Access Compliance Report

Public Rights-of-Way

Intersection ID: 48166	Main Street: NORTHLAKE_MALL_DR	Cross Street: NORTHLAKE_CENTRE_PY	Location: SW
ADA ID: 0B7E2A80DFEA	Ramp Type: BlendTrans2	Initial Pass/Fail: Pass	Overall Compliance: No
		Severity Score: 0.25

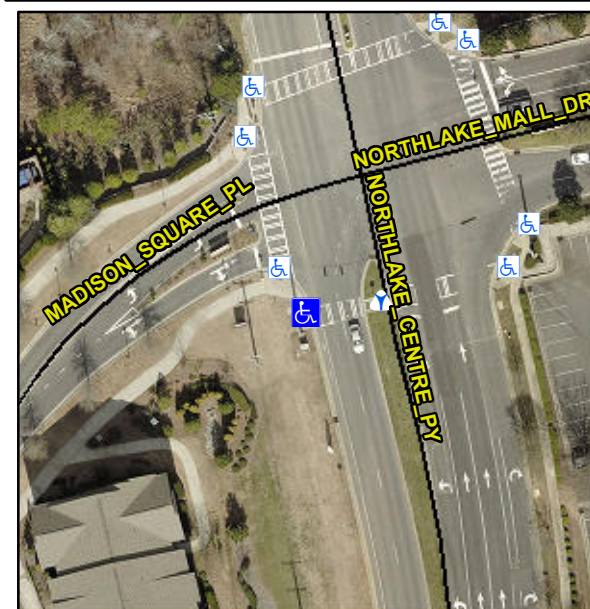
Not Found, R305.2, R304.5.3

Yes	Ramp inside XWalk1?	Yes	N/A	Ramp inside XWalk2?	N/A
	Road Slope (%)	3.7		Clear Space?	Yes
	Road X Slope (%)	1.4	N/A	Clear Space to XWalk (in)	N/A
Yes	Any Obstructions?	No	Yes	Storm Grate/Utility Hazard?	No
	Obstruction Type			Storm Grate/Utility Type	
		N/A			N/A
			Yes	Surface Condition? (G/P)	Good
			No	Curb Slope (%)	7.8

Remove & Replace Curb Ramp With Two New Directional Ramps or Equivalent. Remove & Replace Gutter.
